Connecting Walkway between Courthouse & Detention Center

- Option 1 - Connecting Sidewalk Only
- Option 2 - Concrete Masonry Enclosure
- Option 3 - Wood Framing Enclosure
- Option 4 - Fence Enclosure

ARCHITECTURAL SITE PLAN
 SCALE: 1" = 40'

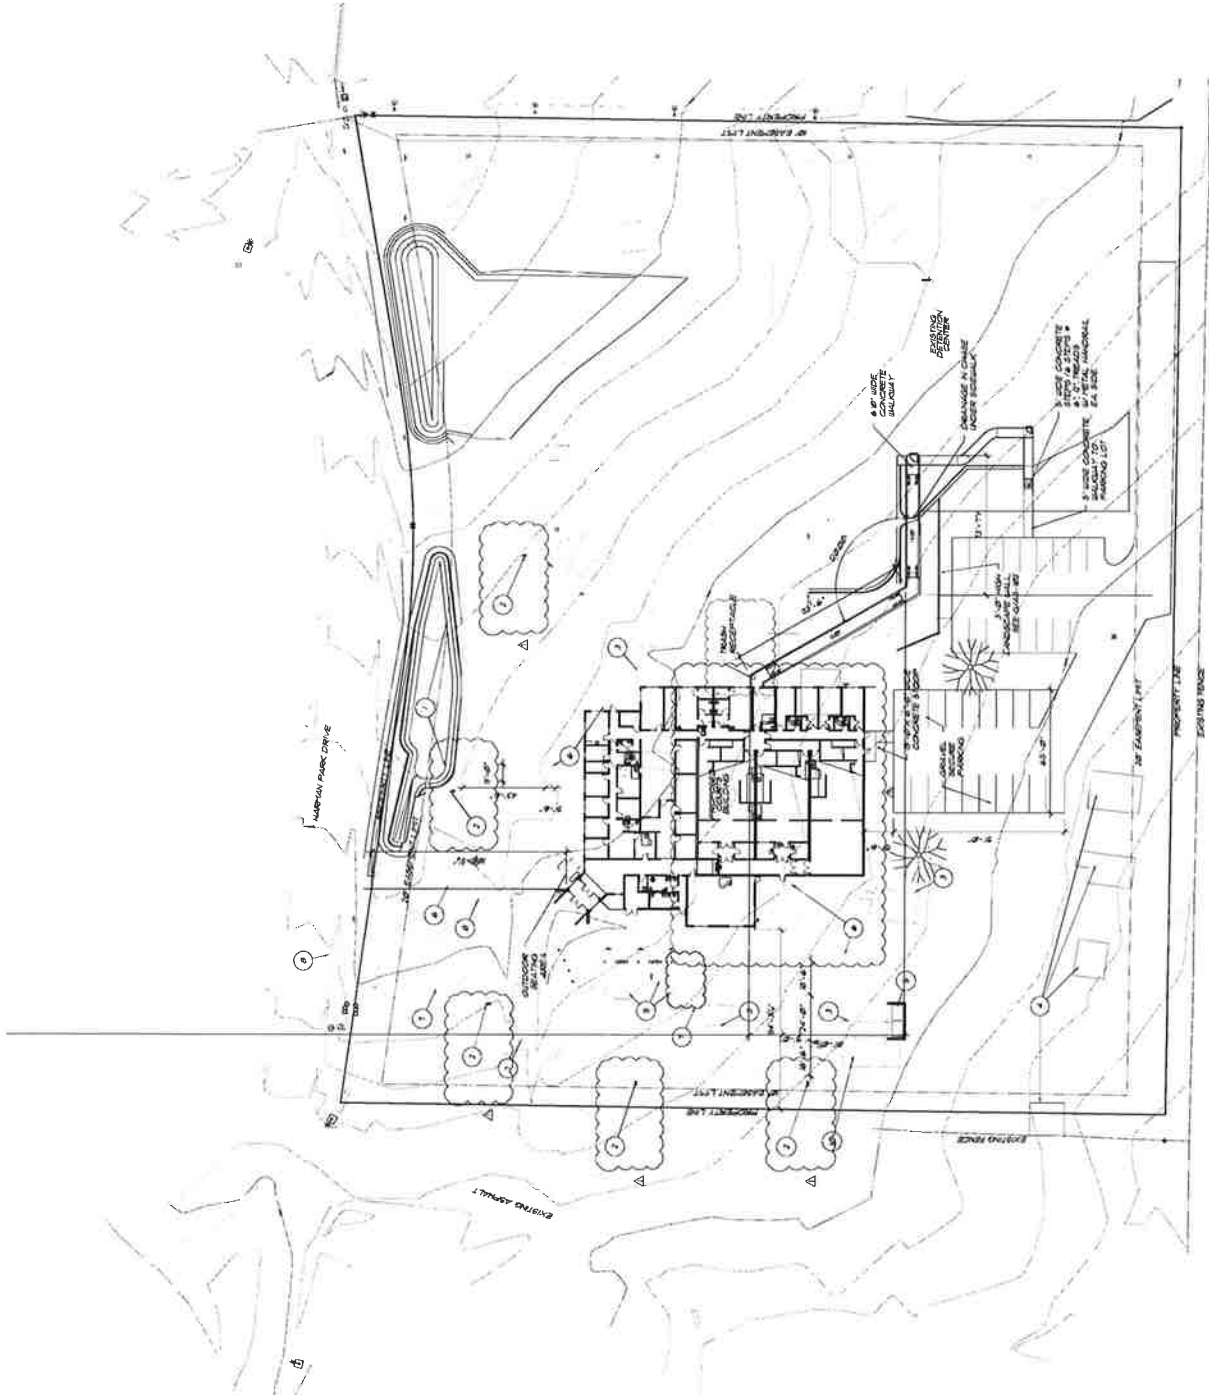
Option 1 includes a basic sidewalk with thickened edges that runs from the courthouse holding cell over to the detention center. There is no enclosed structure for this option. The detention center drive, curb and gutter, and landscaping will have to be slightly modified to accommodate the new walk. A drawing is attached showing the layout. Below are specific inclusions and exclusions for this option:

Option 2 includes a sidewalk with thickened edges and a concrete masonry unit enclosure that runs from the courthouse holding cell over to the detention center. A sloped metal roof will be installed over the two CMU walls. Inside the enclosure will be block walls and a painted hard-lid ceiling with can lights. A conduit for the fiber interconnection between the two buildings has been included inside the slab footprint. The detention center drive, curb and gutter, and landscaping will have to be slightly modified to accommodate the new walk. A drawing is attached showing the layout. Below are specific inclusions and exclusions for this option:

Option 3 includes a sidewalk with thickened edges and a wood framed enclosure that runs from the courthouse holding cell over to the detention center. A sloped metal roof and metal wall panels will be installed on the exterior. Inside will be drywall walls and a painted hard-lid ceiling with can lights. A conduit for the fiber interconnection between the two buildings has been included inside the slab footprint. The detention center drive, curb and gutter, and landscaping will have to be slightly modified to accommodate the new walk. A drawing is attached showing the layout. Below are specific inclusions and exclusions for this option:

Option 4 includes a sidewalk with thickened edges and a chain link fence enclosure that runs from the courthouse holding cell over to the detention center. A conduit for the fiber interconnection between the two buildings has been included inside the slab footprint. The detention center drive, curb and gutter, and landscaping will have to be slightly modified to accommodate the new walk. A drawing is attached showing the layout. Below are specific inclusions and exclusions for this option:
